Our Ref: AWE05.4ECO - HUNTINGWOOD

Re: Proposed Mod 1 / Rev 3 Plan for the AirTrunk Centre at 51 Huntingwood Drive, Huntingwood

Biodiversity Verification Statement

Figure 1 – Proposed Mod DA layout (April 2026)

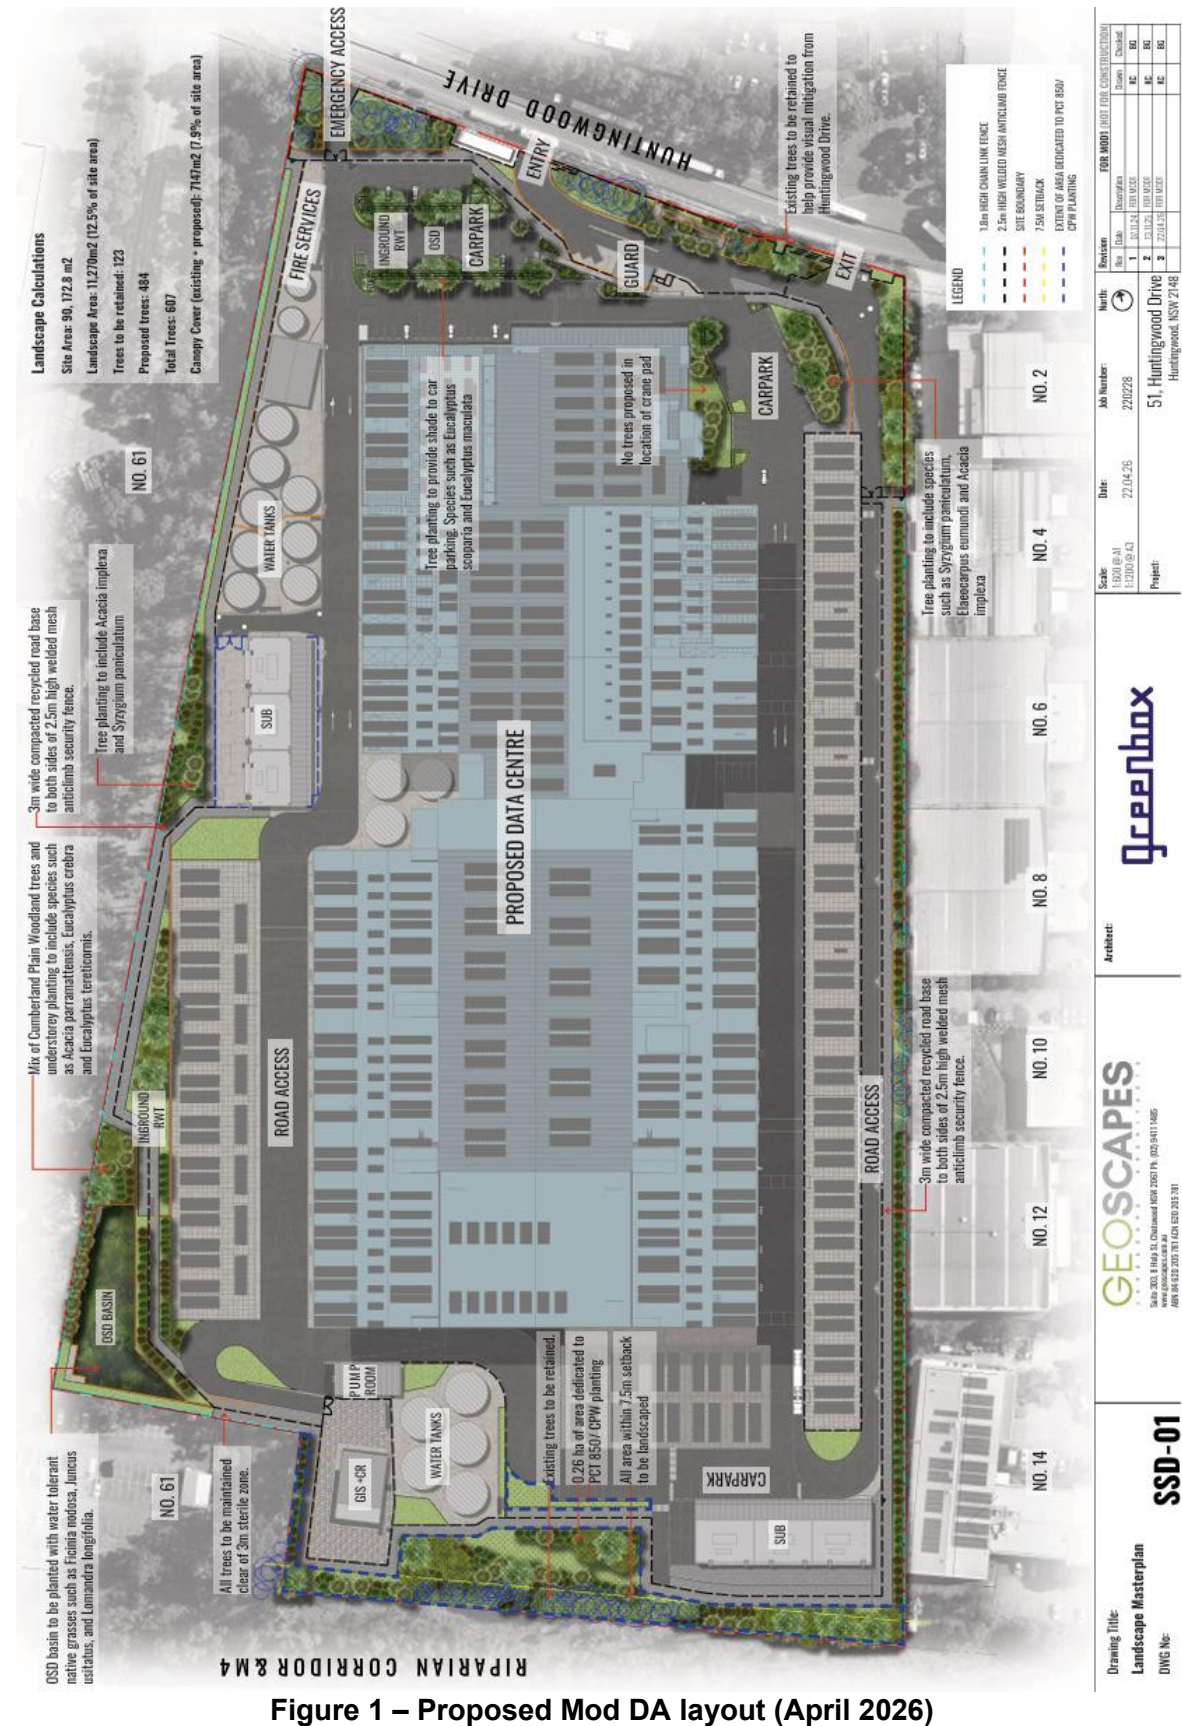
The proposal is being lodged as an S4.55 Mod DA with a modified footprint as per Figure 1, being referred to as Mod 1/ Rev 3.

The updated plan will require 7 not approved trees to be removed and 1 to be removed will now be retained, thus an overall requirement of 6 additional trees in total to be removed. To compensate for the loss of the trees, the landscape plan (Geoscapes) has ensured that additional trees will be planted within the site to compensate for their loss.

- 2274 / 2273 / 2276 – now removed – previously to be retained – 3 less
- 2268 – now removed – previously to be retained - 1 less
- 2272 – now removed – previously to be retained – 1 less
- 2191 and 2262 – now removed due to safety reasons – previously to be removed – no change
- 2261 and 2192 – now removed – previously to be retained – 2 less
- 2189 – retained – previously to be removed – add 1

Difference – 6 additional trees are proposed for removal, all required by Sydney Water for placement of their valve meter.

Figure 2 - Proposed Mod 1/Rev 3 DA design

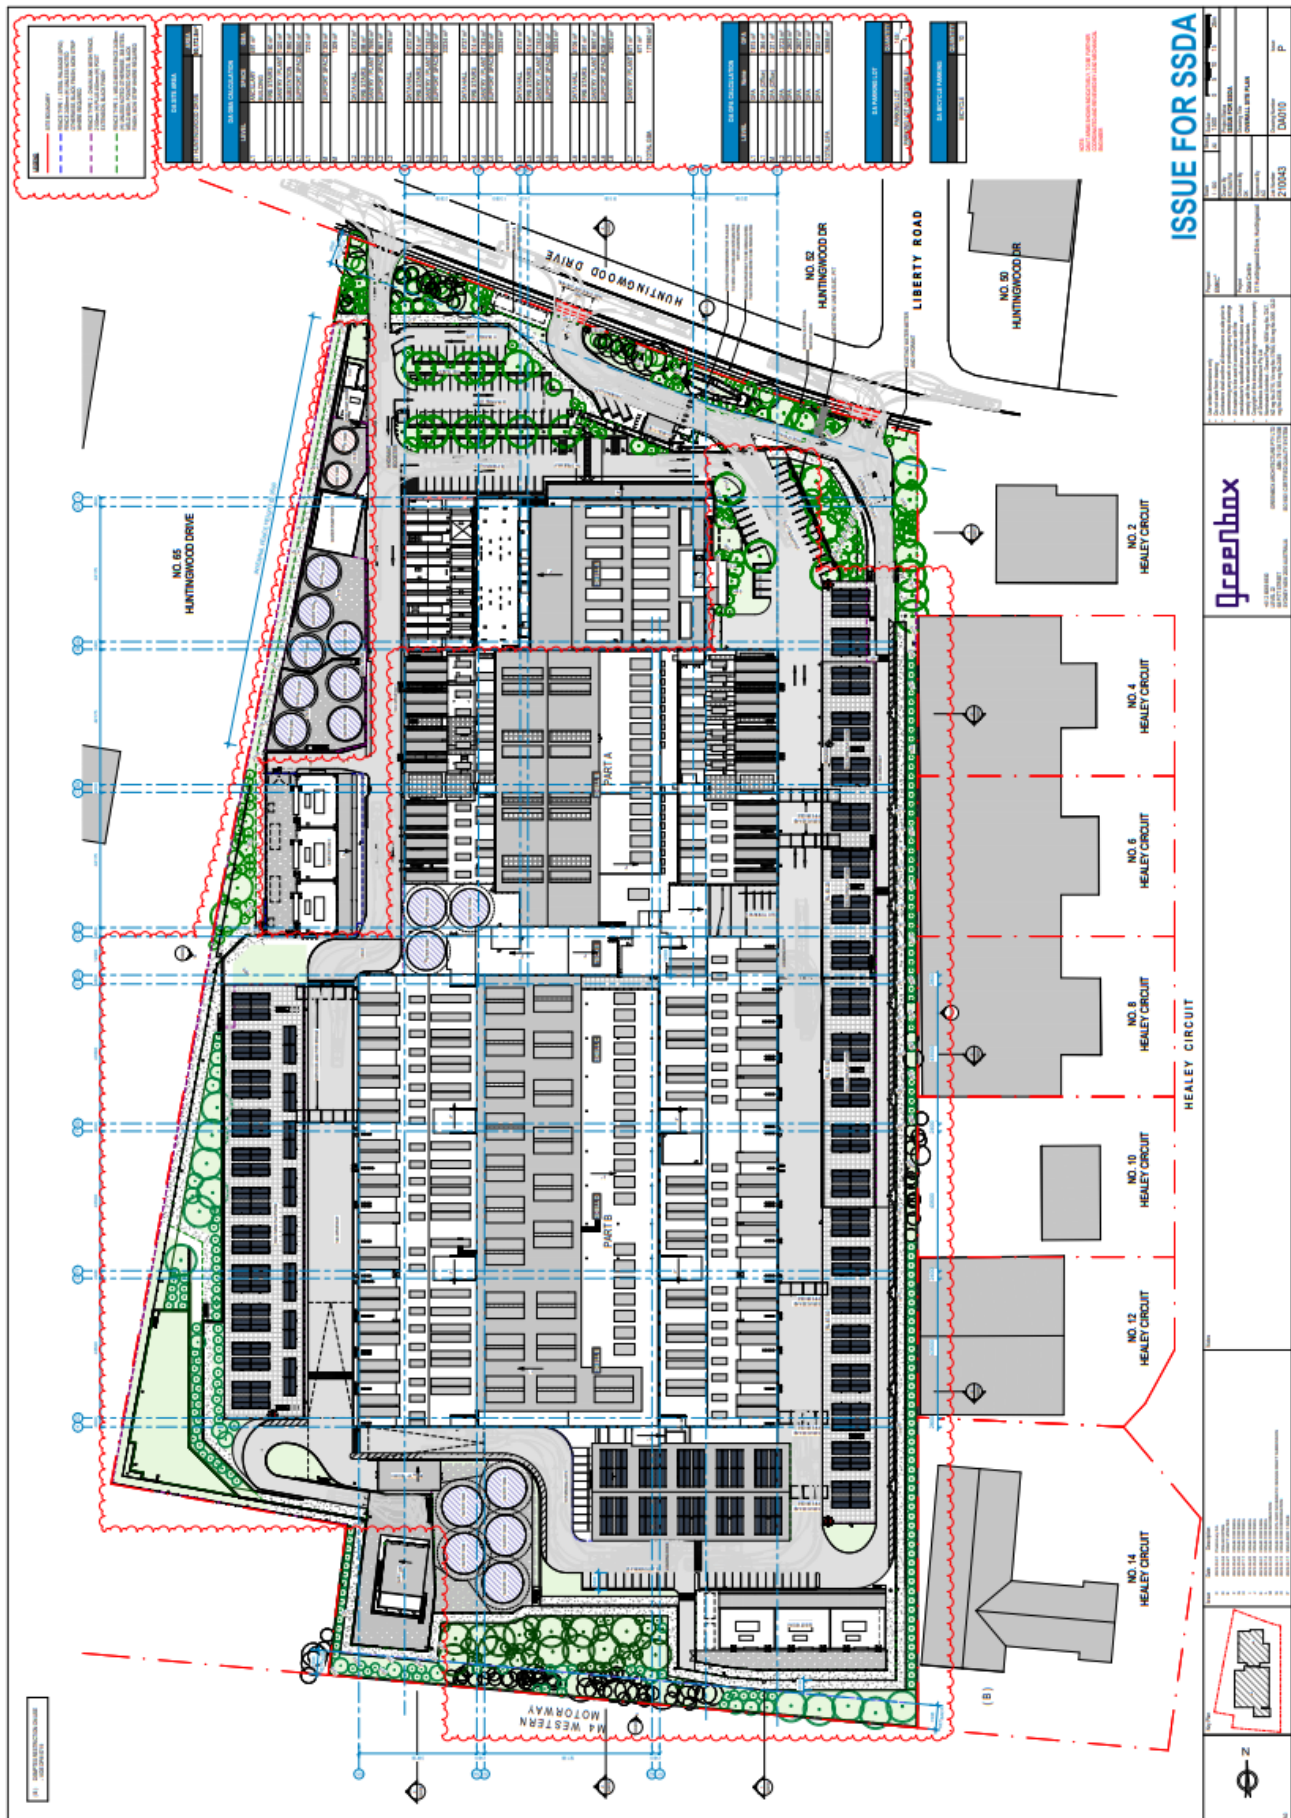
Figures 1 and 2 show the location of said trees on the supplied plans from AirTrunk. The flow valve location has been carefully selected for minimal impact to the tree cover and landscaping, with the area of slab the valve arrangement sits on as per the sketches provided in the landscape plans. All piping is underground and is not affecting any trees or landscaping.

Figure 3 - Former vegetation mapping of the northern portion of the site

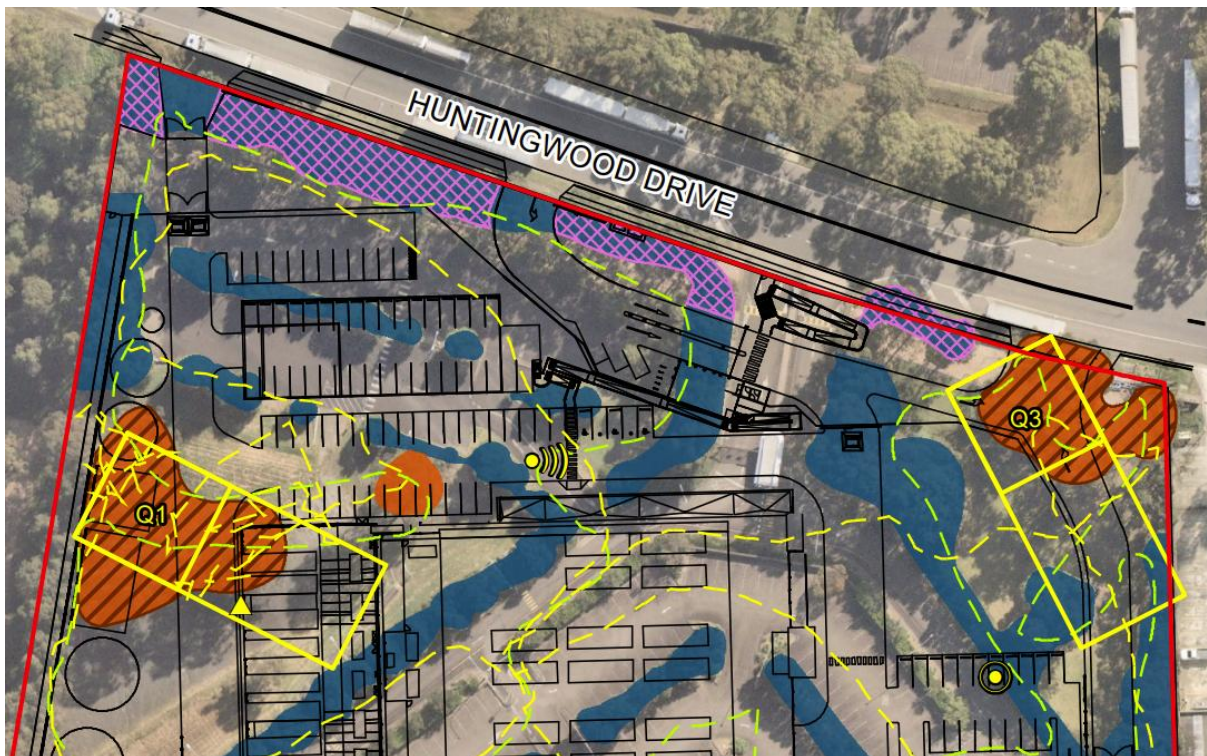
Figure 3 is a snipped diagram from the approved BDAR. The blue colouring indicates planted vegetation whilst the orange colouring indicates remnant Cumberland Plain Woodland. Planted native vegetation has been assessed as a prescribed impact within the BDAR, with no credits required to be offset.

We can confirm that the location of the changes to tree retention and removal are upon planted specimens located near the site entrance within the blue colouring. As such these changes are not affecting any remnant areas of PCT 850 / 3319 (Cumberland Plain Woodland) that would affect biodiversity offsetting requirements. No further changes to the BDAR are required and no obligations for additional offsets will be sought by the modification.
